This document sets out to summarize argument used by by the MSC auditing team in connection the 2017 MSC certification of the Sandeel and Norway pout fishery. The documents have a focus on the response from the Auditing team to comments from NGO's given during the public hearing process.

In order not to repeat the arguments provided in the certification rapport by the independent MSC reviewers, we refer to the MSC certification rapport “MSC Final Report and Determination for DFPO and DPPO North Sea, Skagerrak and Kattegat Sandeel, Norway Pout, and Sprat fisheries” for the scientific justification for the positive evaluation of sandeel and Norway pout when it comes the Ecosystem Impacts.

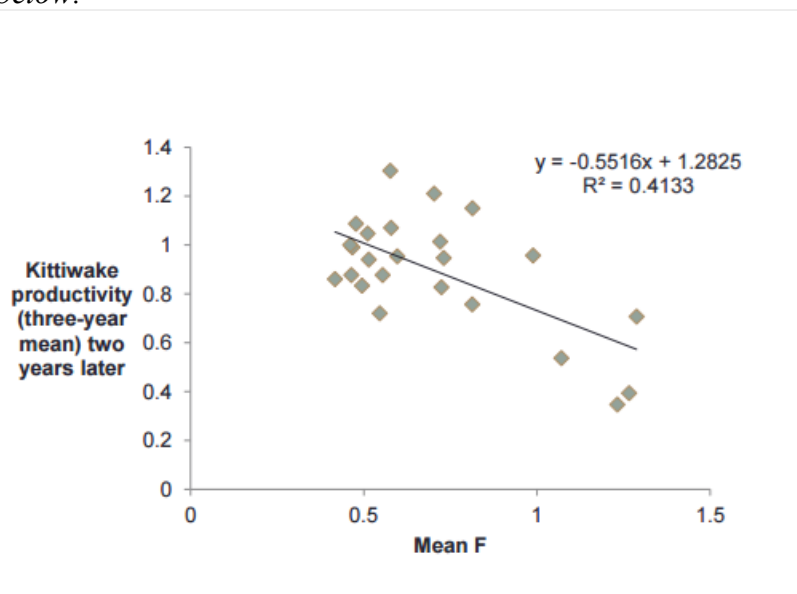
Why there is such a strong signal from fishing mortality with a two year lag is unclear. We would assume that the relationship acts in some way through spawning stock biomass, although the relationship between breeding success and SSB is relatively weak (Kittiwake breeding success increases with SSB but the relationship is strongly influenced by one year of high SSB, and when the trends over time in SSB and breeding success are removed, the relationship is no longer significant: Matthew Carroll, RSPB) ”.

4. MSC certification team answer: “The key evidence presented by the BirdLife report is the correlation between lagged productivity and sandeel fishing mortality. It is reproduced below:

Clearly, in the years where the stock is overfished and $F > 1$ (blue line) there is a negative impact. These points correspond to the years before 2004. Indeed, had the MSC assessment been performed in that period, the scoring would have been very different. However, in the recent decade $F < 0.7$. For those exploitation rates the evidence presented by BirdLife shows no relation between fishing mortality and kittiwake productivity. However the uncertainty about the evidence has to be acknowledged, which is why an SG80 is appropriate rather than 100. To avoid the misrepresentation of the BirdLife report we have removed the following citation from the report text and scoring table altogether. The conclusion in 2.3.1c is indeed bizarre when read out of context. The statement is simply a repetition of the MSC criteria for the guidepost as given in the headings of the table, and meant to distinguish between the certainty required at the SG80 (highly unlikely) vs SG100 level (high degree of confidence). No changes to the scoring have been made.”
